DEPARTMENT OF THE AIR FORCE

04 APR 1990

RE: NMEID Notice of Violation Letter (1 Mar 90) Landfill 5 Cell 3 Closure

AS BUILT DRAIN  
DITCH DETAIL NTS

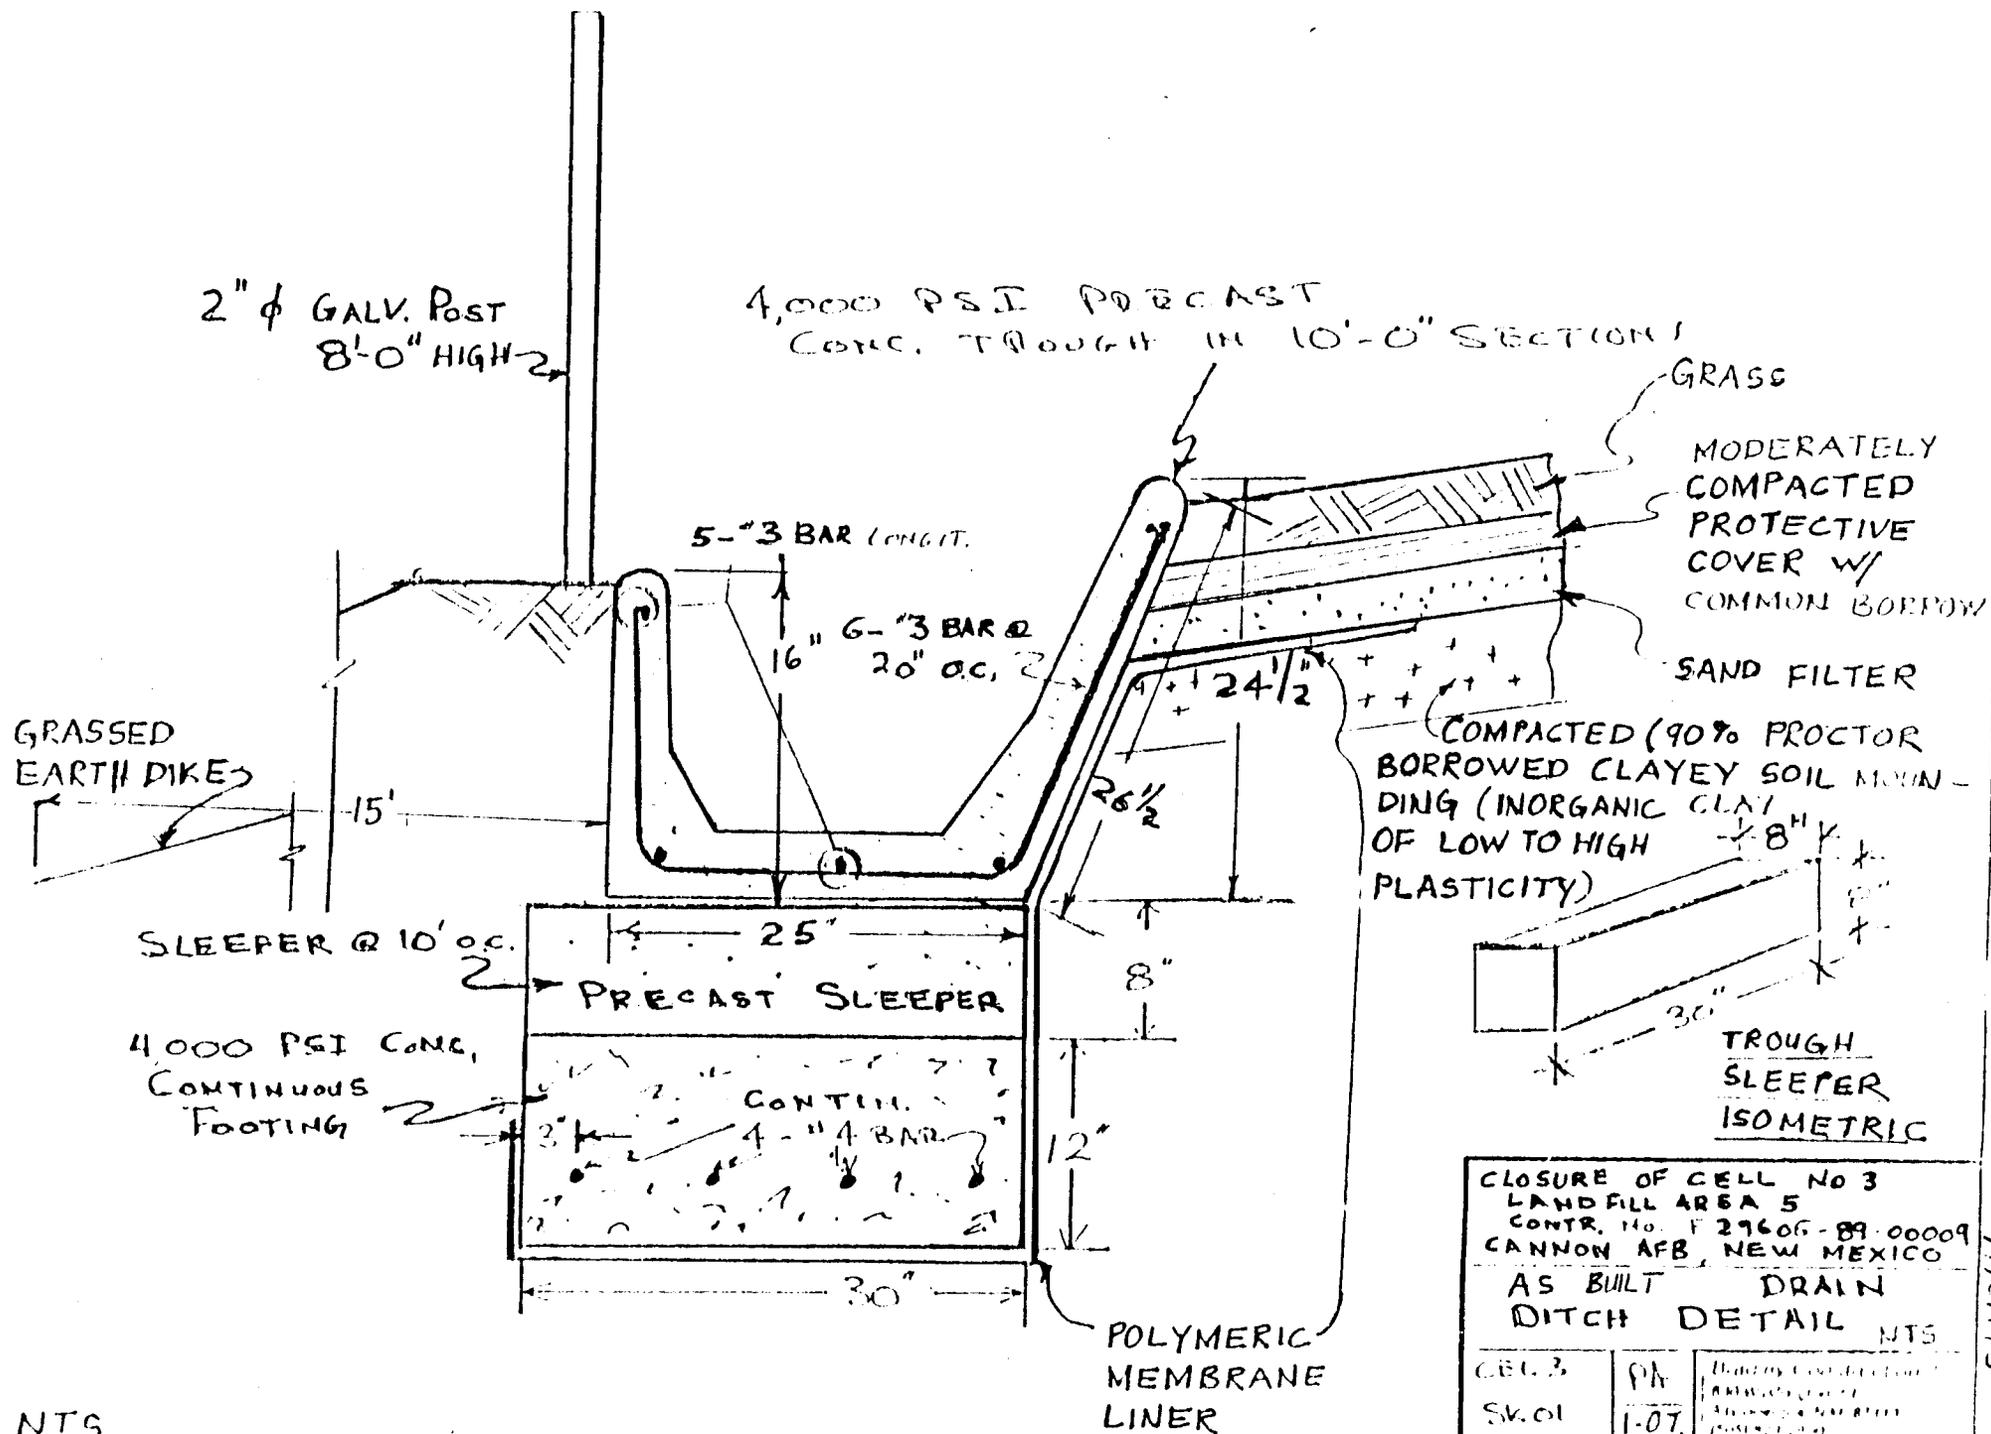
The attached revised As-Built submittal dated 1 Jul 89 (Atch 13) was in review prior to initiating site preparation work. As shown, the drain trough was placed on a twelve inch thick, reinforced structural concrete footing. The footing is shown in the project photos. The approved change was based on engineering judgement.
